UNITED STATES PATENT AND TRADEMARK OFFICE

Office Action Summary

10/579,852

DETAILED ACTION

Annotated FIG 8

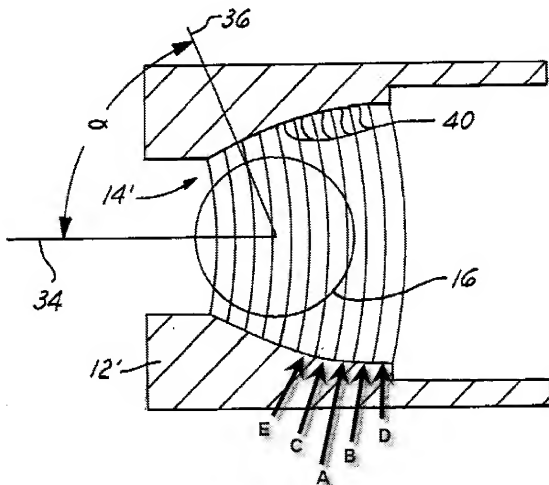
3. Claims 8-11, 14 and 15 are rejected under 35 U.S.C. 102(e) as being anticipated by Talaski (US 2005/0016599).

Regarding claim 8, Talaski discloses (see annotated FIG 8, below) a valve having a valve member (16) which cooperates with a valve seat (14') formed in a housing part (12') in order to control a connection, the valve seat having an at least approximately conical seat face (A) which is located at a transition of the connection from a portion of small diameter (left, FIG 8) to a portion of large diameter (right, FIG 8), wherein the seat face (A), on its side oriented toward the portion of large diameter (right), is adjoined by at least one face (B) which is more markedly inclined toward the longitudinal axis of the connection than the seat face (angle α is larger, see explanation in paragraphs 21 and 27) and wherein the seat face, on its side oriented toward the portion of small diameter, is adjoined by at least one face (C) which is less markedly inclined toward the longitudinal axis of the connection than the seat face (angle α is smaller).

Regarding claim 9, Talasaki discloses the face (B), adjoining the seat face (A) toward the portion of the connection having the large diameter (right), to be adjoined by at least one further face (D), inclined more markedly toward the longitudinal axis of the connection (angle α is further increased).

Regarding claims 10 and 11, Talasaki discloses the face (C) adjoining the seat face (A) toward the portion of the connection having the small diameter (left) to be adjoined by at least one further face (E), inclined less markedly toward the longitudinal axis of the connection (angle α is further decreased).

Regarding claims 14 and 15, the side of the connection from which the surfaces are machined would not impart any distinctive structural characteristics. This process of manufacture therefore does not further define the claimed valve.

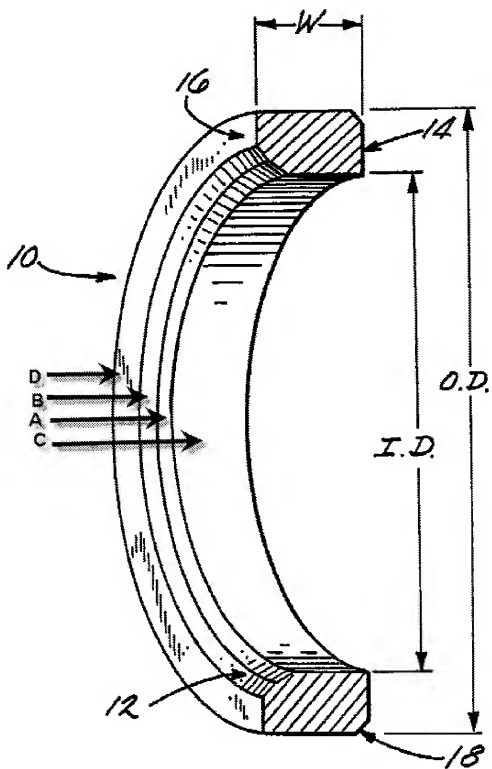
4. Claims 8, 9, 14, 15, 18 and 19 are also rejected under 35 U.S.C. 102(b) as being anticipated by Trudeau (WO 99/64202).

Regarding claim 8, Trudeau discloses a valve having a valve member (inherent) which cooperates with a valve seat (see annotated FIG below) formed in a housing part in order to control a connection (inherent, to contain and control flow), the valve seat having an at least approximately conical seat face (A) which is located at a transition of the connection from a portion of small diameter ("ID") to a portion of large diameter ("OD"), where the seat face (A), on its side oriented toward the portion of large diameter, is adjoined by at least one face (B) which is more markedly inclined toward the longitudinal axis of the connection than the seat face (A) (for purposes of the following analyses, the angles are defined as those between the longitudinal axis and a line perpendicular to the face in question; in this case the angle defined in part by face B is smaller than that defined in part by face A, and is therefore "more inclined toward" the longitudinal axis) and wherein the seat face (A), on its side oriented toward the portion of small diameter, is adjoined by at least one face (C) which is less markedly inclined toward the longitudinal axis of the connection than the seat face (angle is larger).

Regarding claim 9, Trudeau discloses the face (B), adjoining the seat face (A) toward the portion of the connection having the large diameter, to be adjoined by at least one further face (D), inclined more markedly toward the longitudinal axis of the connection (angle is further decreased).

Regarding claims 14 and 15, the side of the connection from which the surfaces are machined would not impart any distinctive structural characteristics. This process of manufacture therefore does not further define the claimed valve.

Regarding claims 18 and 19, Trudeau's faces are hardened (col. 1 line 66).
